# Access Compliance Report

## Public Rights-of-Way

Intersection ID: 29681	Main Street: DARLINGTON_RD	Cross Street: EQUESTRIAN_DR	Location:	N
ADA ID: 1DA4D0EBC970	Ramp Type: PerpDiag	Initial Pass/Fail: Fail	Overall Compliance: No	Severity Score: 10

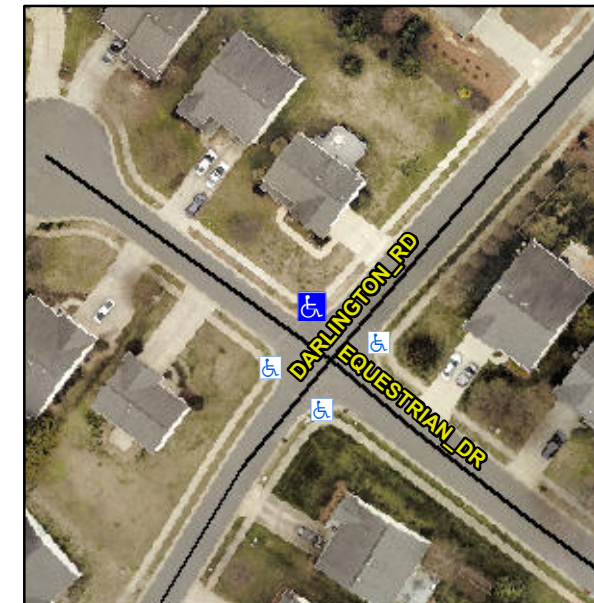
**Not Found, R304.5.1, R304.5.3**

Compliance	Description	Data	Compliance	Description	Data
N/A	Ramp Length (in)	49.5	Yes	Ramp Slope (%)	6.1
No	Ramp Width (in)	47.0	No	Ramp XSlope (%)	4.7
N/A	Flare Type LT	N/A	N/A	Flare Type RT	N/A
N/A	Flare Slope LT (%)	N/A	N/A	Flare Slope RT (%)	N/A
N/A	Flare Traversable LT?	N/A	N/A	Flare Traversable RT?	N/A
N/A	Landing Length (in)	N/A	N/A	DWS Provided?	N/A
N/A	Landing Width (in)	N/A	N/A	DWS Contrast?	N/A
N/A	Landing Slope (%)	N/A	N/A	DWS Length (in)	N/A
N/A	Landing X Slope (%)	N/A	N/A	DWS Full Width?	N/A
N/A	Landing Curb? (Y/N)	N/A	N/A	DWS Offset (in)	N/A
N/A	Shared Landing?	N/A			
N/A	Gutter Ponding?	N/A	N/A	Gutter Slope (%)	N/A
N/A	Gutter Lip Ht (in)	N/A	N/A	Gutter X Slope (%)	N/A
N/A	Painted X Walk1?	No	N/A	Painted X Walk2?	No
	X Walk 1 Direction	To SW		X Walk 2 Direction	To SE
N/A	X Walk 1 Width (in)	N/A	N/A	X Walk 2 Width (in)	N/A
	X Walk 1 Slope (%)	5.6		X Walk 2 Slope (%)	2.9
	X Walk 1 X Slope (%)	1.1		X Walk 2 X Slope (%)	4.2

**Remove & Replace Curb Ramp With Two New Directional Ramps or Equivalent.**
